Access Compliance Report
Public Rights-of-Way
(Curb Ramps)

Main Street: JUDY_ANNE_LN **Cross Street:** CHADBOURNE_LN **Location:** NE

ADA ID: RPRK220125134437 **Ramp Type:** Type 4 - Parallel **Initial Pass/Fail:** Fail **Overall Compliance:** No **Severity Score:** 2

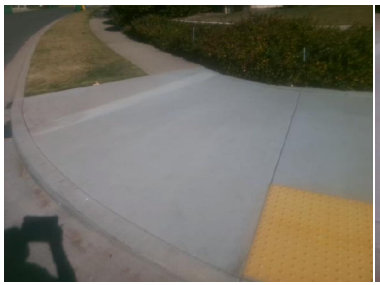
Compliance	Description	Data	Compliance	Description	Data
N/A	Ramp Length LT (in)	110	N/A	Ramp Length RT (in)	89
Yes	Ramp Width LT (in)	134	Yes	Ramp Width RT (in)	134
Yes	Ramp Run Slope LT (%)	2.8	Yes	Ramp Run Slope RT (%)	5.1
No	Ramp Cross Slope LT (%)	4.2	No	Ramp Cross Slope RT (%)	4.4
N/A	Landing Present	N/A	N/A	DWS Provided	N/A
N/A	Landing Length (in)	N/A	N/A	DWS Contrast	N/A
N/A	Landing Width (in)	N/A	N/A	DWS Length (in)	N/A
N/A	Landing Run Slope (%)	N/A	N/A	DWS Full Width	N/A
N/A	Landing Cross Slope (%)	N/A		DWS Offset Type	N/A
N/A	Landing Movement Obstructed?	N/A	N/A	DWS Offset Left (in)	N/A
	Landing Movement Type	N/A	N/A	DWS Offset Right (in)	N/A
N/A	Landing Shared	N/A			
N/A	Clear Space	Yes			
N/A	Clear Space To Crosswalk (in)	N/A			
N/A	Marked Crosswalk 1	No	N/A	Marked Crosswalk 2	No
	Crossing 1 Direction	W		Crossing 2 Direction	S
	Marked Crosswalk 1 Width (in)	N/A		Marked Crosswalk 2 Width (in)	N/A

Remove & Replace Curb Ramp With Two New Directional Ramps or Equivalent.

R304.5.3, STD 1115
